estimating bid document addendum 03

project: Cobscook Bay State Park - Shower Building & Utility Improvements
Dennysville, Washington County, Maine BGS # 3473

date: 27 June 2024

COBSCOOK BAY STATE PARK - PLAYGROUND EQUIPMENT DIAGRAM

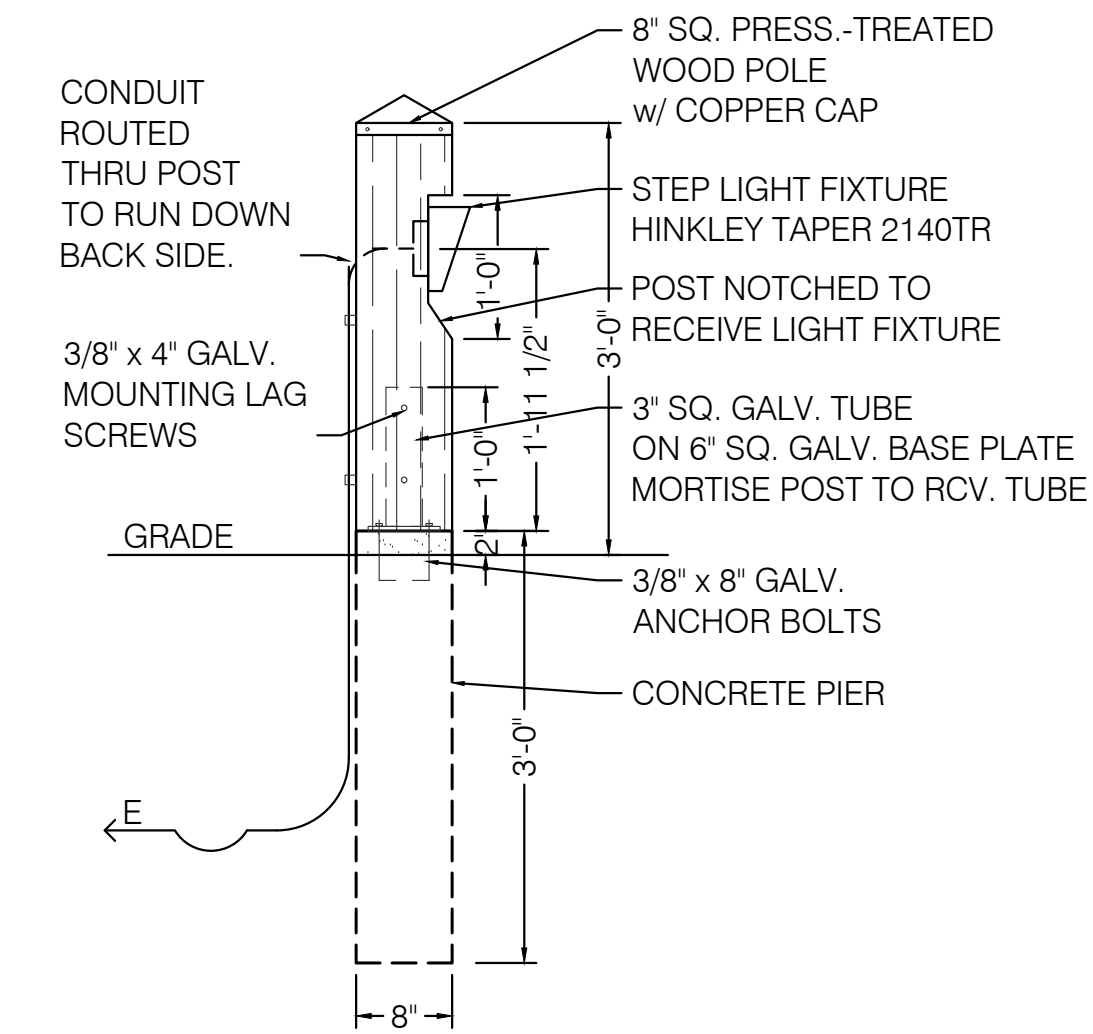
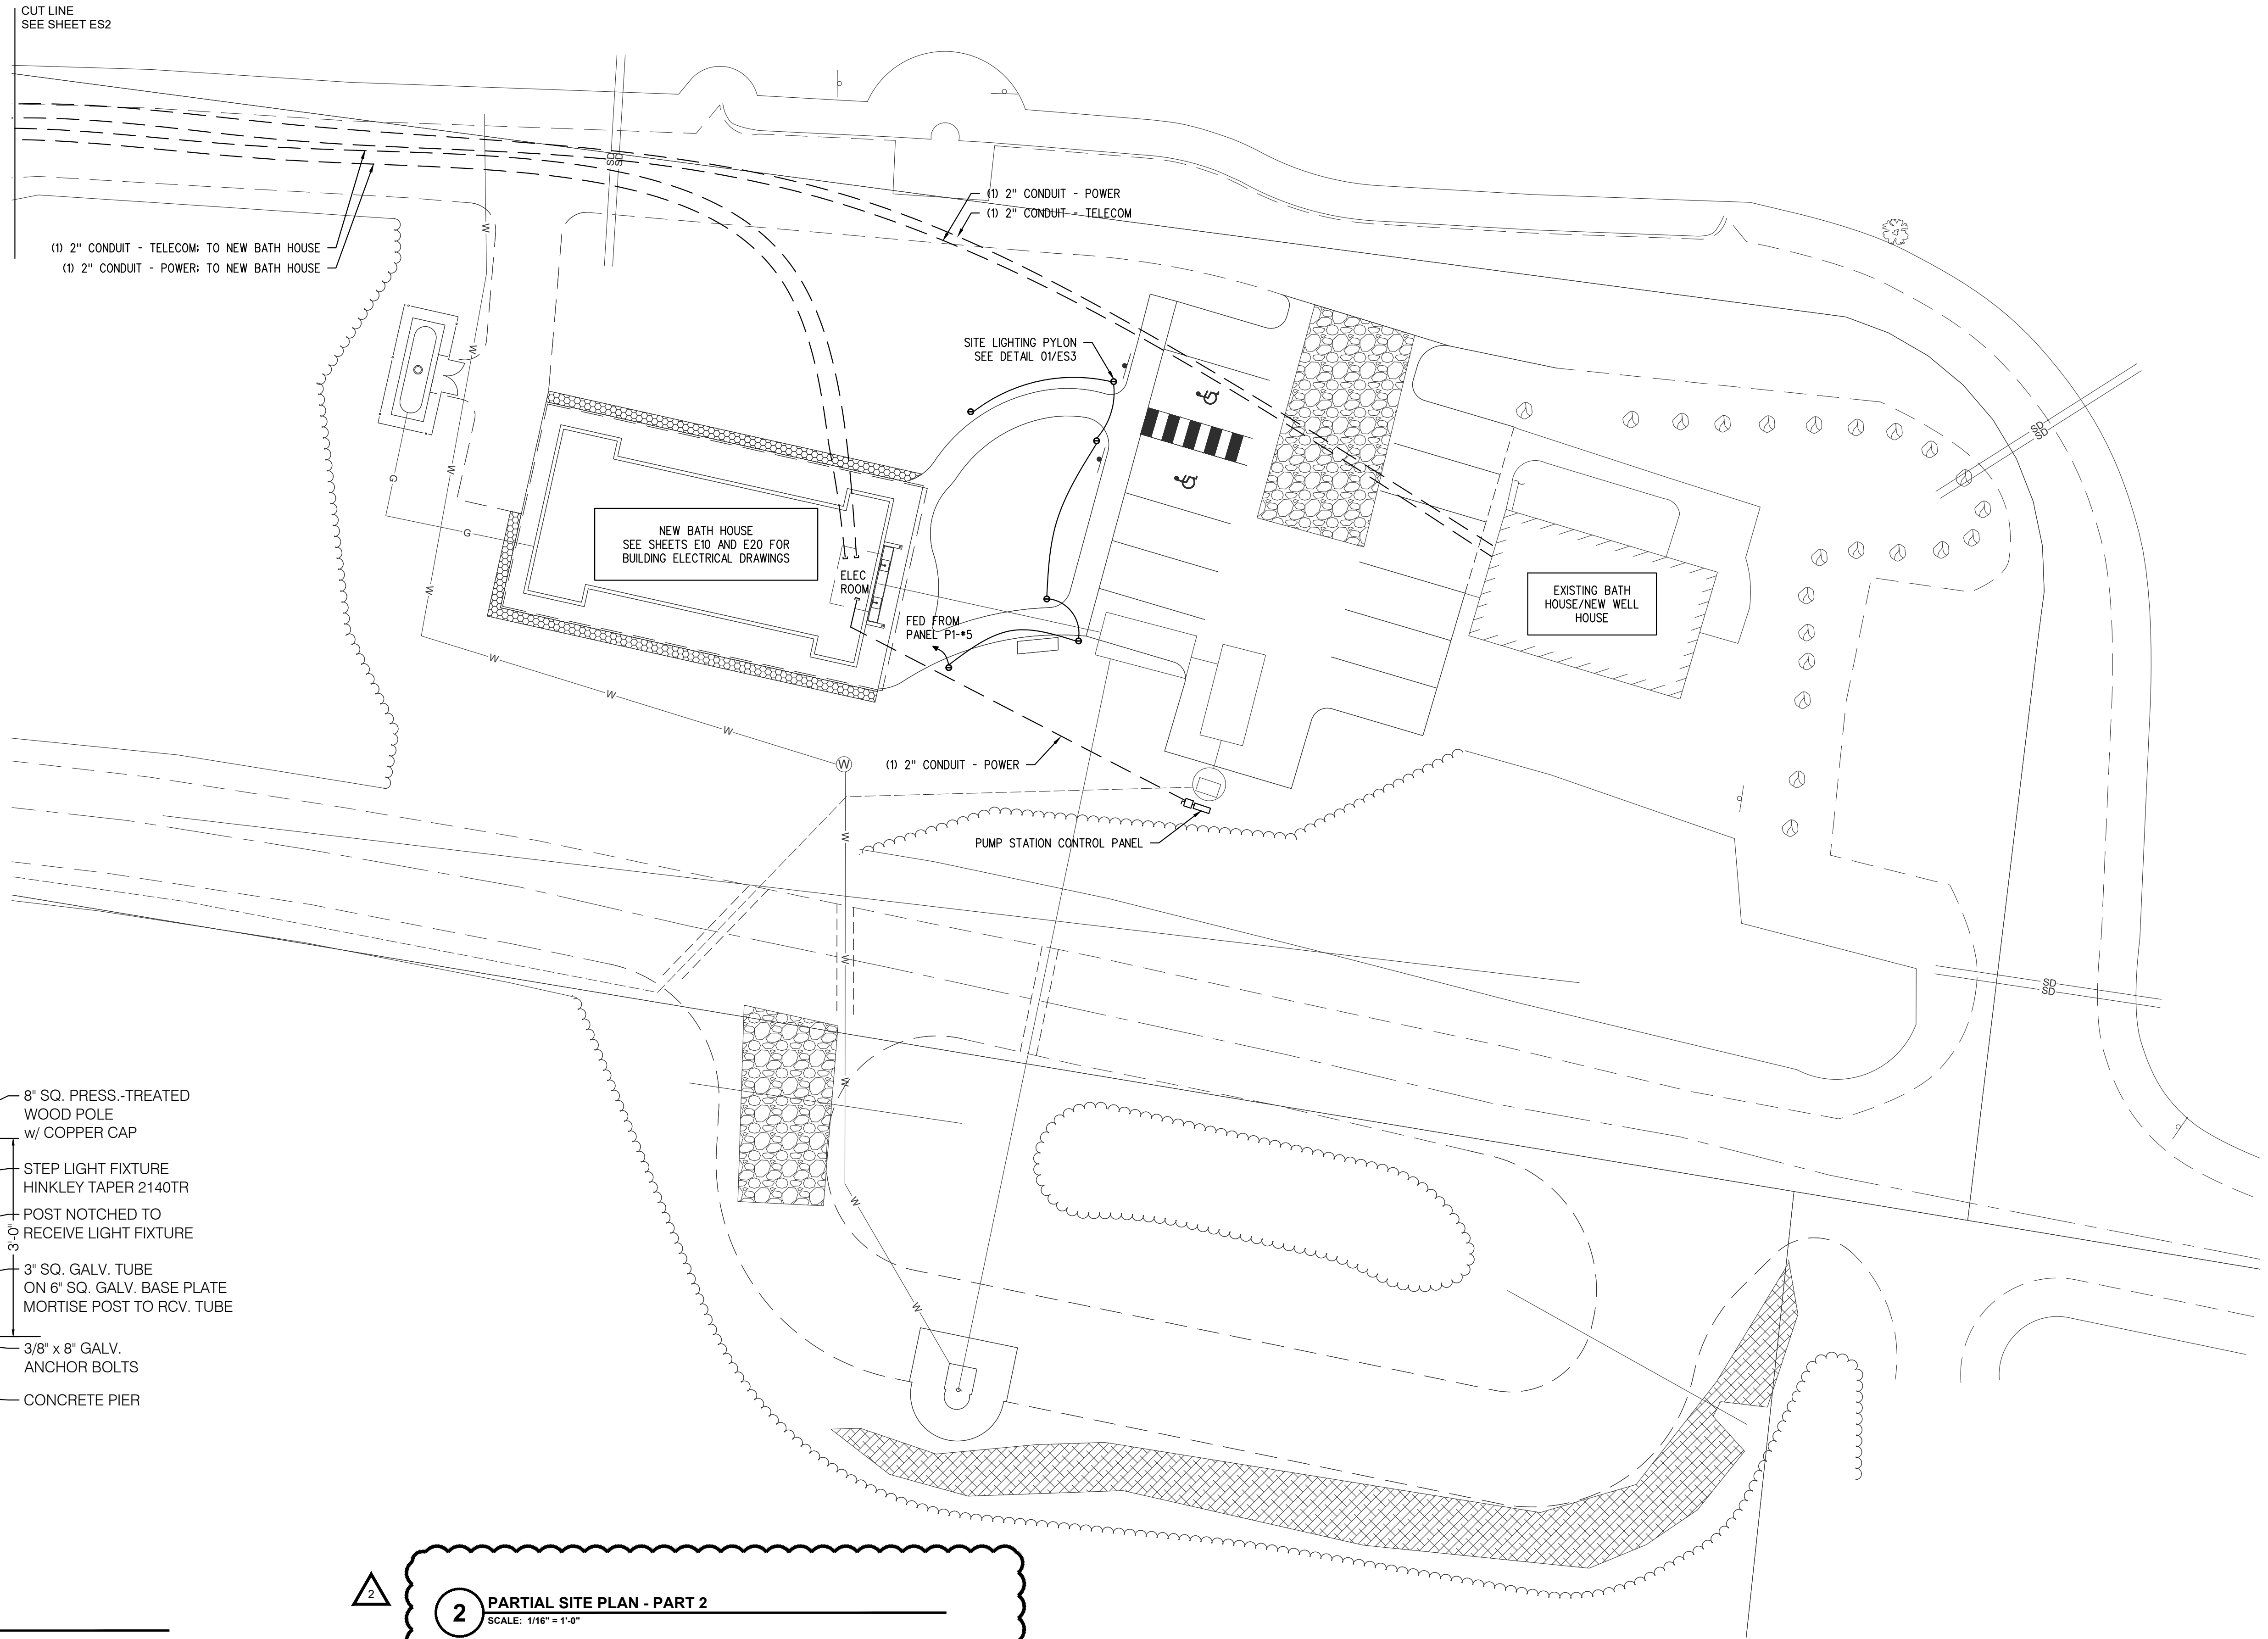
1. Attached partial Sheet A70 shows complete demolition note.
2. Sheet A01. Wood roof framing to receive specified stained sealer. It does not need to be pressure treated.
3. DIVISION 10 SPECIALTIES
Playground Equipment - All existing playground equipment to remain and to be protected during installation of new equipment. New features specified to be located per the attached diagram.
